November 26, 2018

Re: Permit No. M-1980-244; Cripple Creek & Victor Gold Mining Company (CC&V);
Cresson Project; – Addendum to VLF2 Liner Inspection TR#100 PAR Response

Figure 1 Potholing Investigation

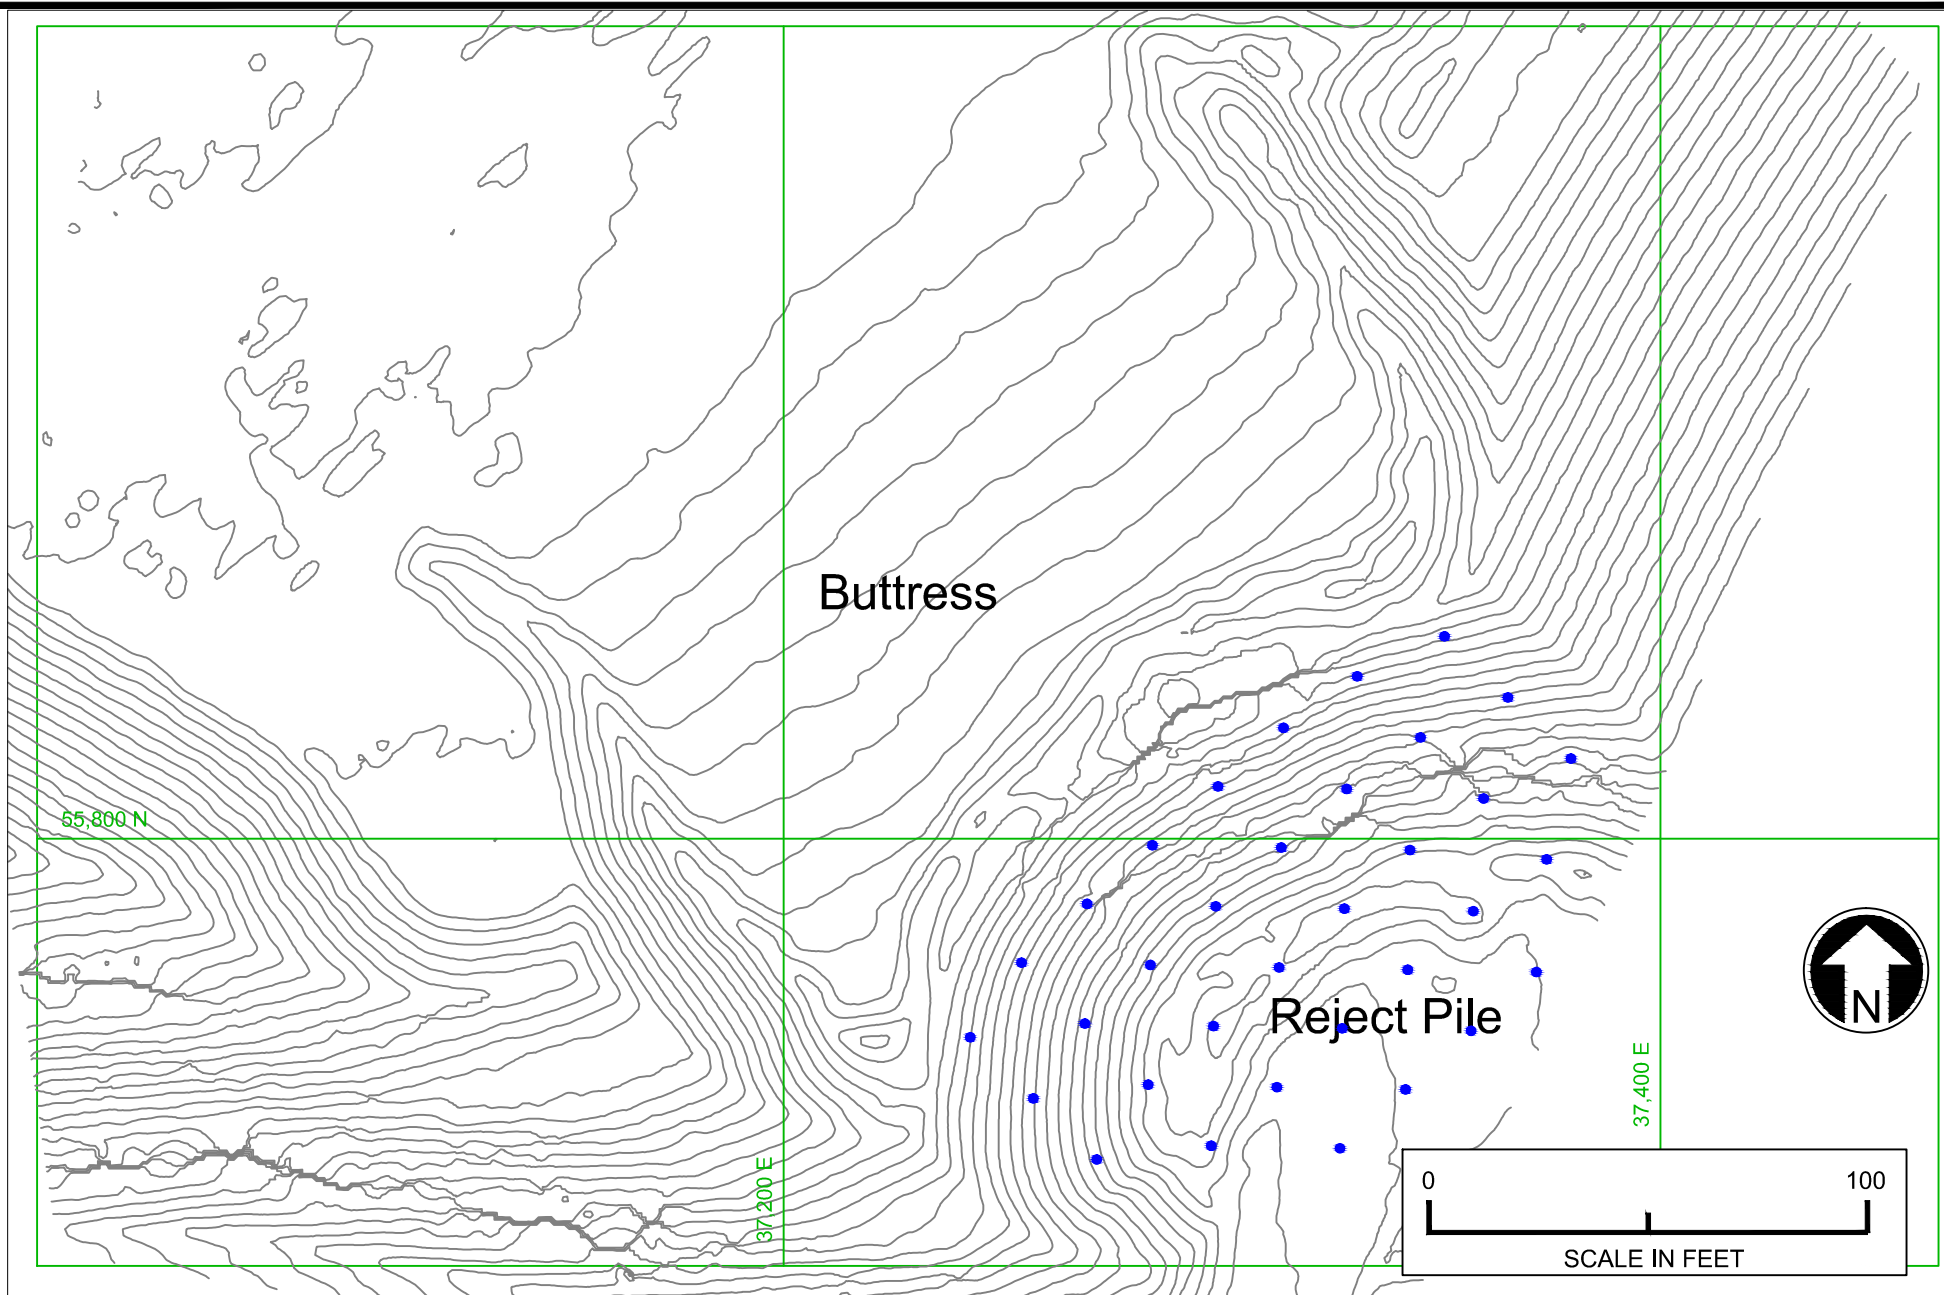
The Division has only one comment of the proposed investigation plan: the proposed pothole investigation plan grid appears to avoid the top (crest) and the flanks of the Reject Pile (please see the red outline in the image included below). The Division is concerned about potential rotational movement that may have been initiated as equipment was beginning to push down the reject material, but may have been subsequently covered up while pushing additional reject material down slope. Please expand the pot-holing investigation to include the crest and flanks (northeast and west sides) of the Reject Pile.

CC&V agrees to expand the potholing locations in the areas identified by DRMS. Figure 1 has been updated to display the proposed potholing locations.
